Project: New Orleans Municipal Yacht Harbor

Subject: Response to Public Comments

Date: January 13, 2017

MN Reference: 9523

Phase 1: Construction

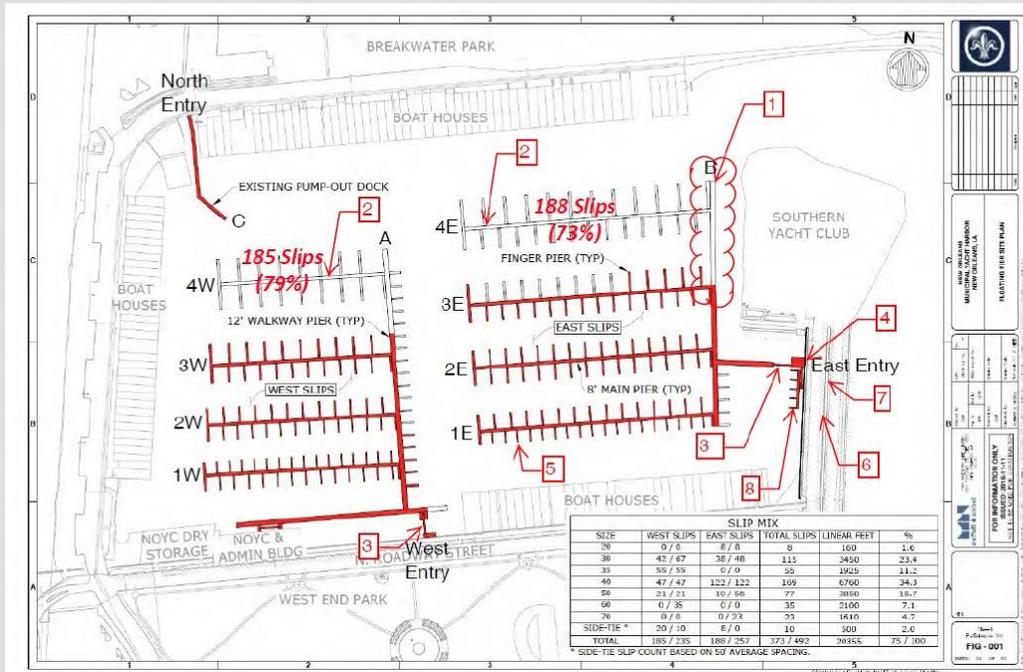
22. The attached slide above the November 15, 2016 presentation by Moffatt & Nichol to the MYHMC Board styled “Phase 1: Construction” and the rendering presented at that meeting do not include a designation as to which slips are the eight listed 20’ slips or the distance from the southeast corner to the southern side of the walkway to the east pier. But, it appears possible that these depict: (1) a planned encroachment on the property covered by the attached lease between Community Sailing New Orleans, Inc. and New Orleans Municipal Yacht Harbor Management Corporation; and (2) slips that do not comply with the slip size requirements of that lease.

The Demised Premises extend 331’ 1” from the starting point at the southeast corner (see Lease Section 1.3 and Demise Premises exhibit). If the walkway out to the east pier is any nearer to that point than 331’ 1”, it will be encroaching on the leased premises and must be relocated in a manner that will cure that potential breach. By this communication CSNOI formally requests that the plans for harbor restoration accurately reflect that required distance and not include an encroachment on the CSNOI/MYHMC Demised Premises.

The attached Phase 1: Construction drawing does not indicate which of the slips are the eight listed 20’ slips. In the event that those are the slips to the east in the drawing, located within the Demised Premises under the attached lease, they are not of the size required by the lease.

- see Section 1.3, more particularly the description of Portion B;
- then look at the Demised Premises exhibit (“which is incorporated herein by reference”);
- then look to the 56’ 4” dimension of Portion B;
- then look at the length of depicted “Slips 1 – 8” (specifically identified in Section 1.3), comparing the distance from the outer pile to the dock at the eastern end of the slips;
- these are the same 30’ slips that were there pre-Katrina.

The City and MYHMC, pursuant to the lease, are obligated to furnish those 30’ slips and this communication respectfully requests that the current version of the harbor restoration plans be amended to reflect compliance with that lease obligation.

At this time, the plans under review are in the Schematic Design Phase and will continue to be refined as the design phase is completed in April 2017. The City will work with MYHMC to ensure the coordination of leasehold areas are accurate during design and construction.

Also refer to Response #1, See Exhibits 3, 4, 5 and 6.

Existing pier entrances, and associated parking

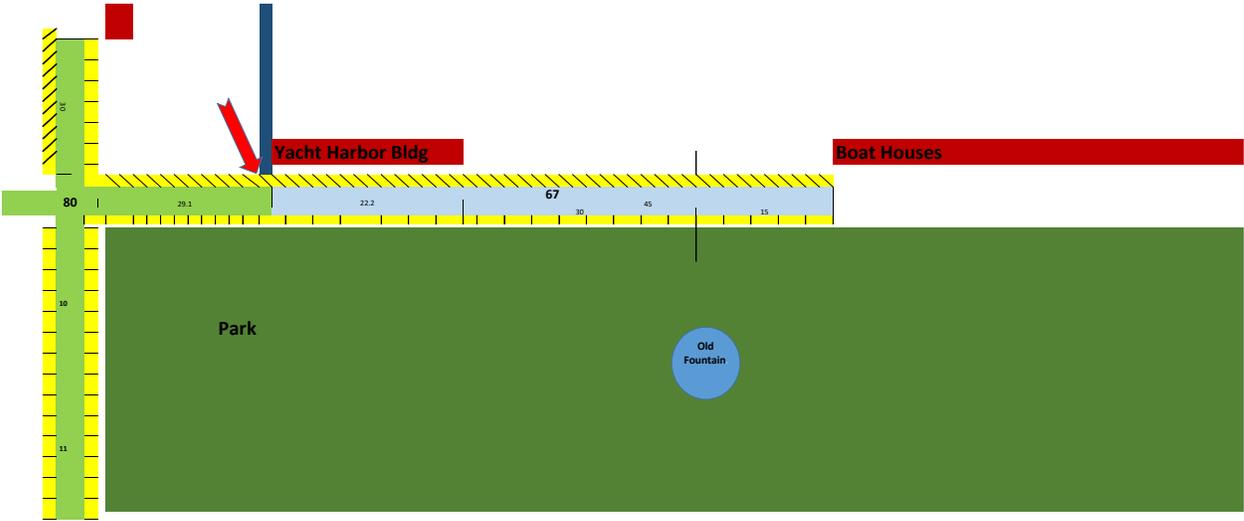
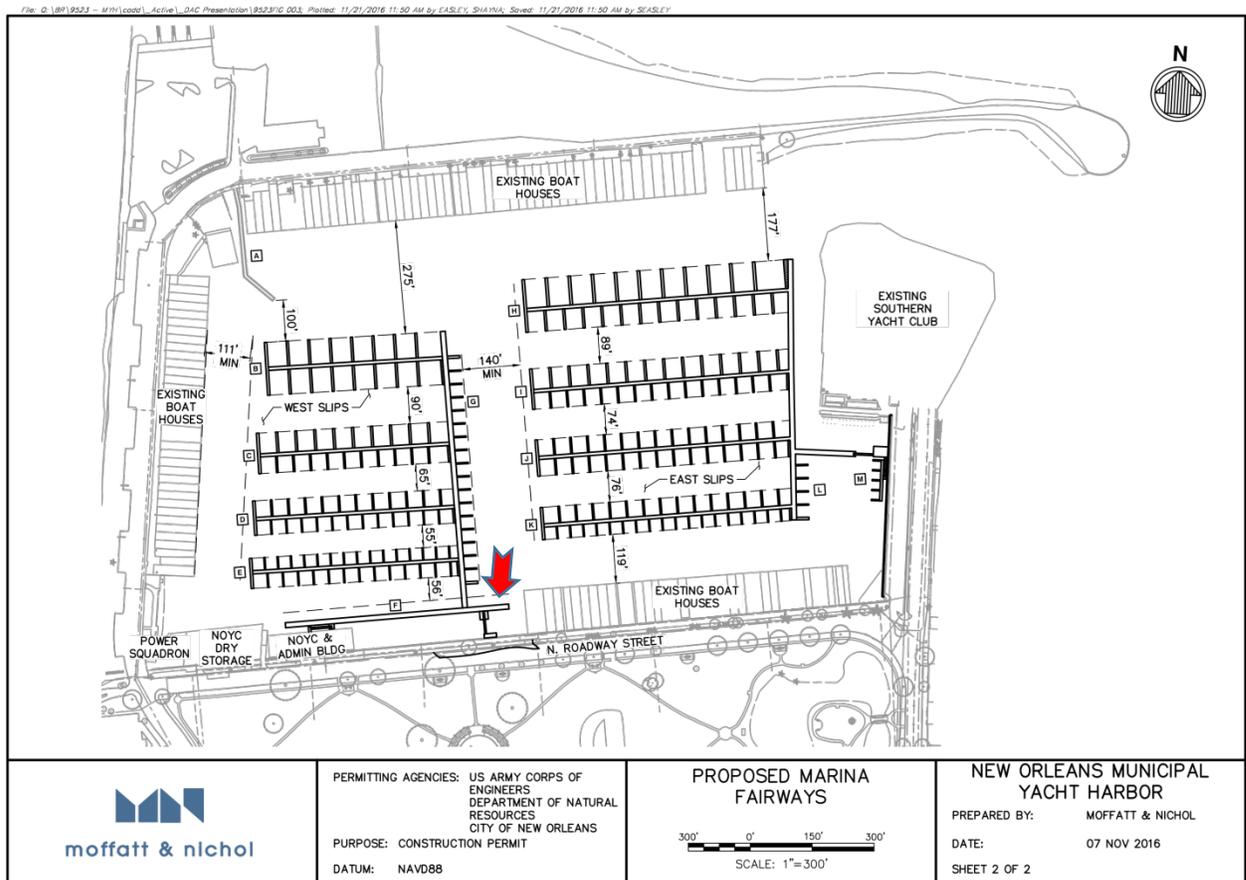
29. We (the boathouse owners) would like the design committee to consider leaving the entrance of the new southwest pier on the southwest end of the marina, and not move it to the east (closer towards the boat houses on north roadway (and the center of the park).

There is not a lot of parking in the marina area, but the entrances to the current slips are near parking lots that can handle the additional vehicles of the people using their boats. Currently the large parking lot on the southwest end of the marina is closed while the new pumping station is being built. During the busy boating times parking will back up down North Roadway to the east and down Breakwater Drive to the north. When the number of boats is increased to 235 then this will get much worse. In the near future we hope to regain access to that parking area, but until then we will have to rely on the street parking to handle all of the parking. When/if the parking lot reopens it will give some relief if it is close to the entrance to the new pier.

We believe that leaving the entrance on the west end will make it easier for the boaters, and it will also not take away parking at the boat houses on North Roadway. The street parking capacity is approximately 80 parking places to the west of the existing entrance, and 67 to the east (prior to the start of the boathouses). The existing pier entrance is as close to being in the center of the street parking as possible.

Please see the attach document for the diagrams of the new pier, existing pier, and street parking.
(Diagrams excerpted below)

The street parking for the current entrance is fairly balanced on each side of the pier entrance with approximately 80 spaces to the west of the existing entrance, and 67 entrances to the east of the entrance (prior to the boat houses).

The proposed West Marina Plan has secondary access points via gangways from the old main pier entrance and the Administration Building.

For the Parking issues, please refer to [General Discussion Points – Marina Parking Requirements and Availability at West End.](#)

Generally, sailing within a marina basin is not recommended due to limited space. Sailboats either maneuver in the marina under power or are provided assistance to move to more open water. It is understood that this recommended practice is not the standard for this marina. The layout is further being evaluated related to this condition.

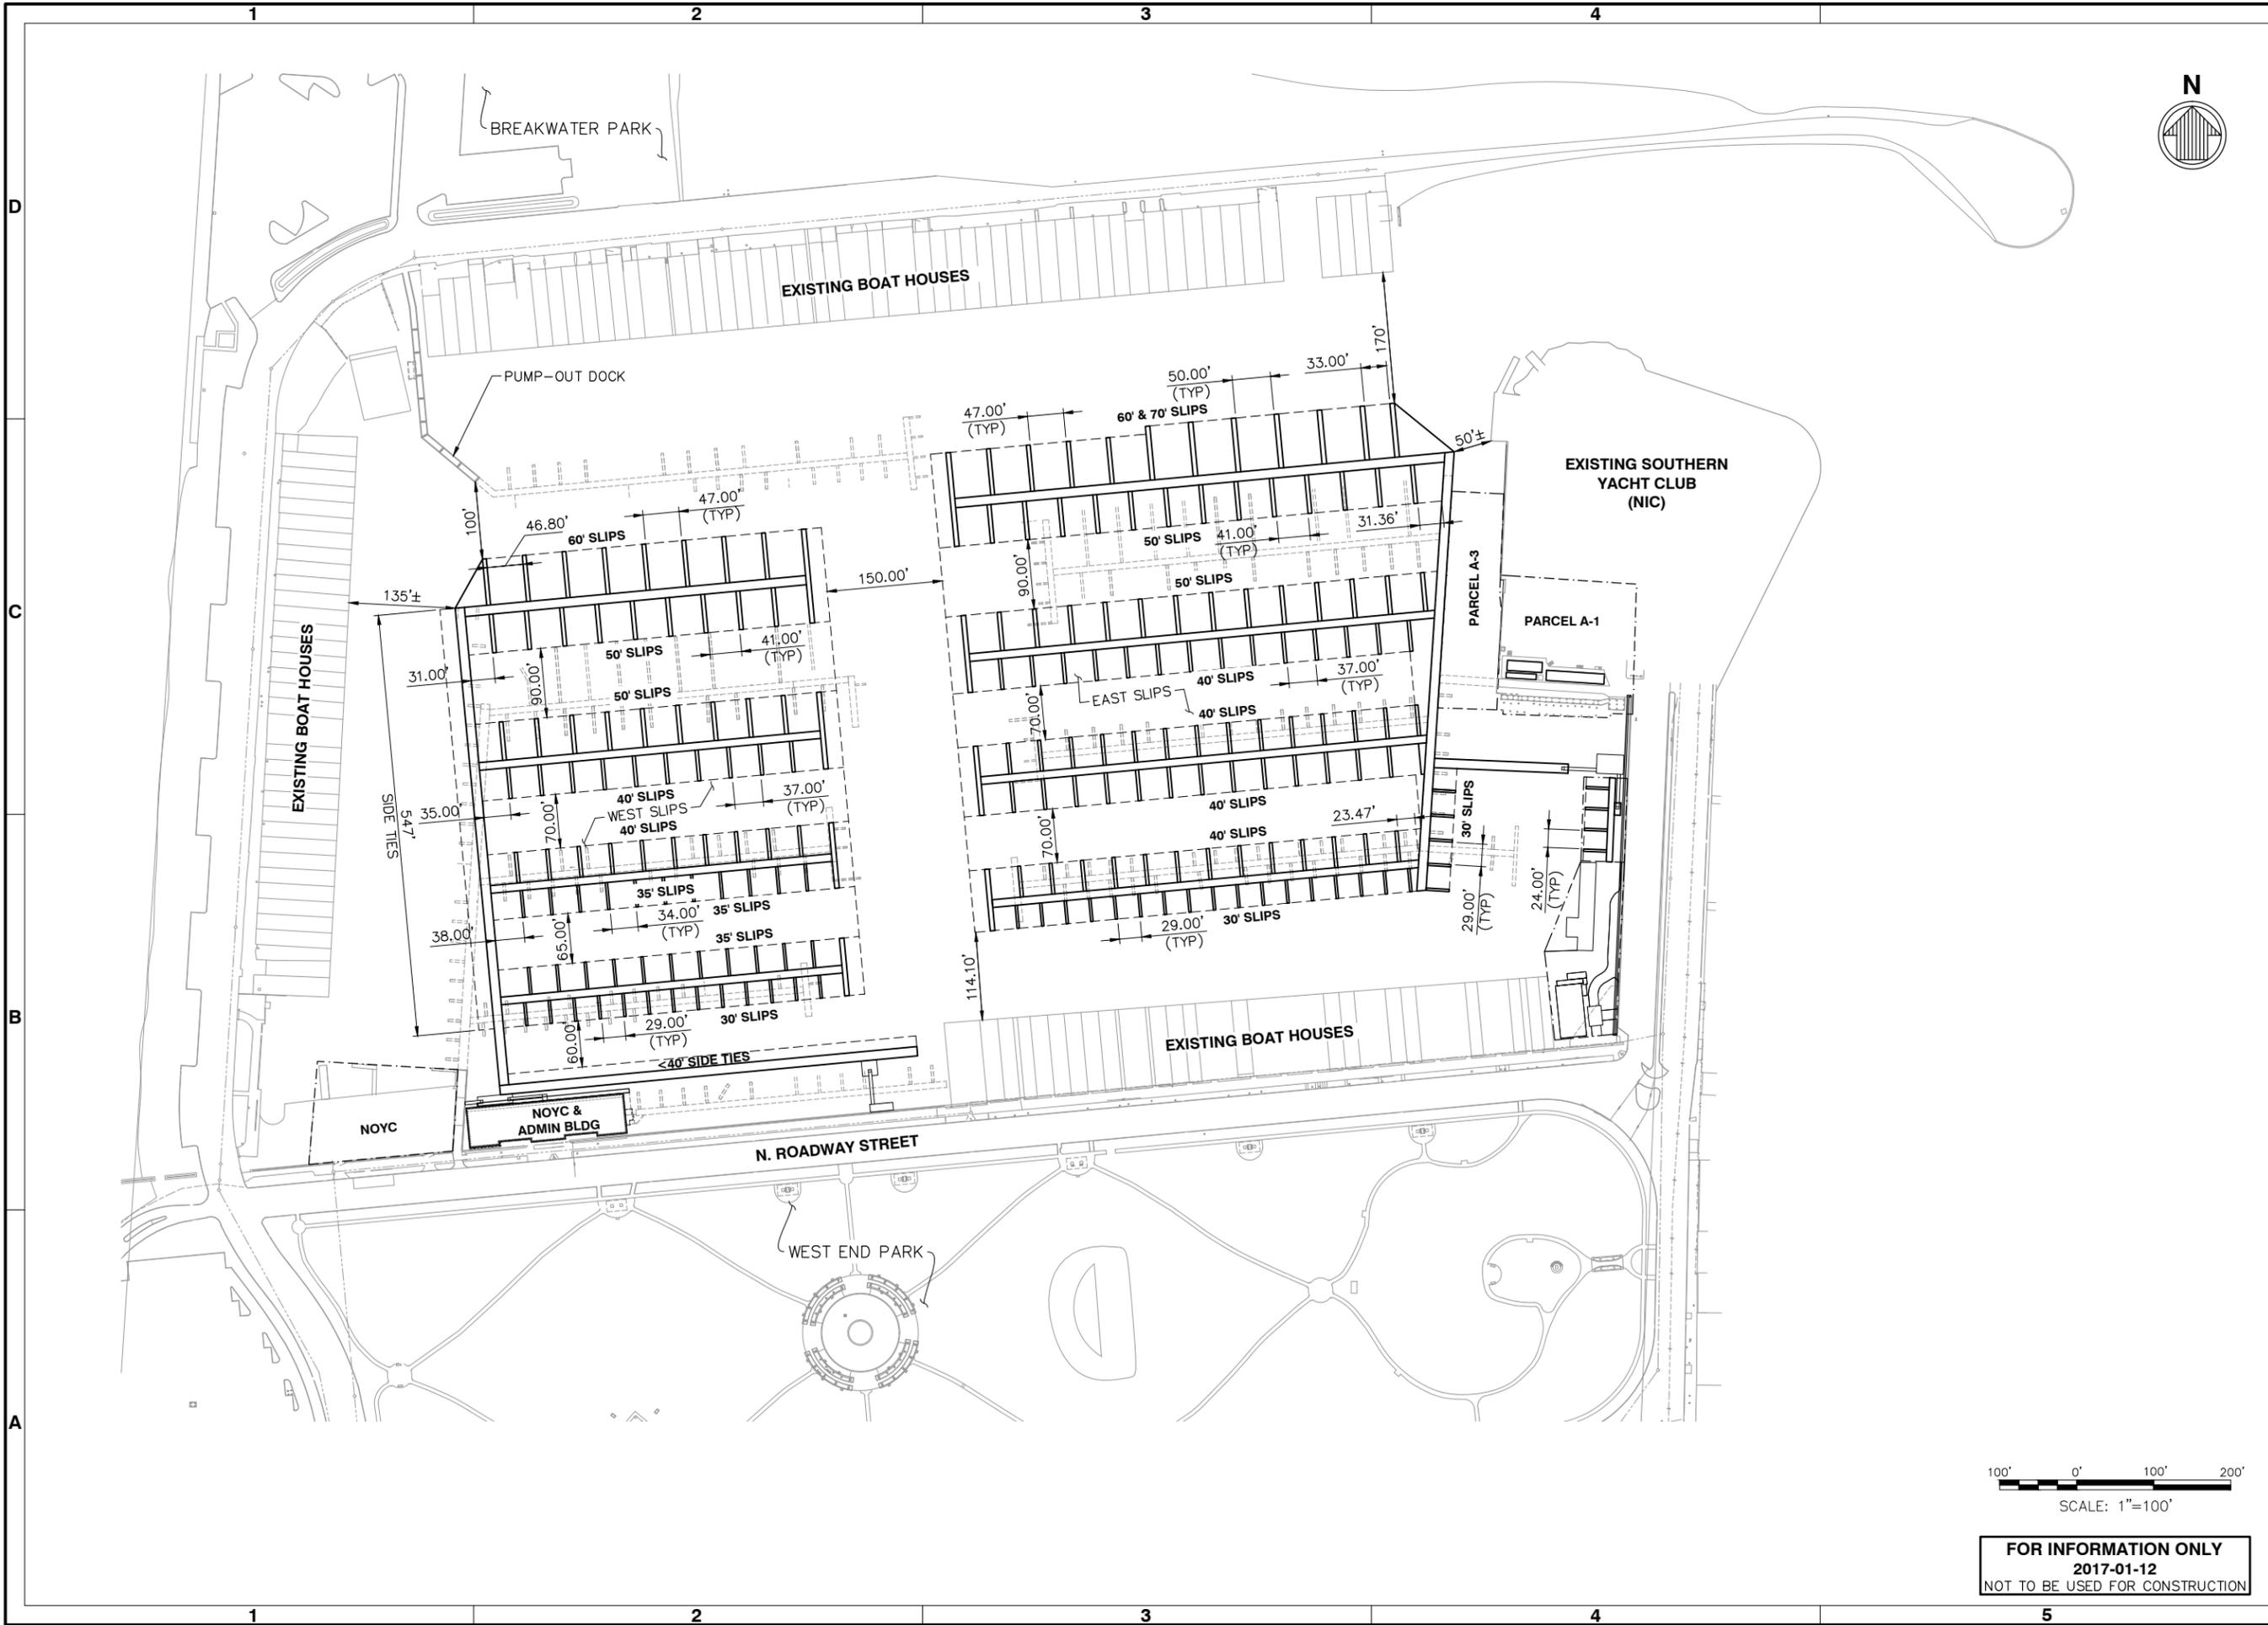
1) there is already a higher than normal build up of sea rocks and other manmade concrete that have begun to form a ridge and overtake the views of the ridge existing pre K. that impairs the waters edge views out towards the lake from the lower levels and lower patios of the boathouses on breakwater, and of pedestrians and driving sightseers. thus i do not feel dumping of additional mud and debris residuals in the process of maintenance dredging proposed for restoring the marina is a palatable approach.

4) views of the lake waters edge should be maintained; that would include not planting arbor or foliage, low or high, that blocks immediate views of the waters edge or lake views. presently there is an overgrowth leading to the point creating blockage of water views from the road.

in particular, may i point out a set of trees that inhibits some dramatic sight lines of the lake for some boathouses balconies and their lakeside interiors. it is overreaching the street of breakwater drive in the form of a cluster of palms at the end of the row of boathouses numbered in the 90's that compromise the otherwise expansive lake view and harbor entrance viewed from boathouse row. consider diminishing of these palms to restore the view.

Please refer to [General Discussion Points – Scope of Dredging](#). The City and MYHMC will follow up on specific issues that may not have been answered. The vehicles you have identified are due to the many construction projects currently underway by private citizens. The same applies to electrical utilities with private developments. At this time the City can only address projects under the scope of the Marina Redevelopment plans.
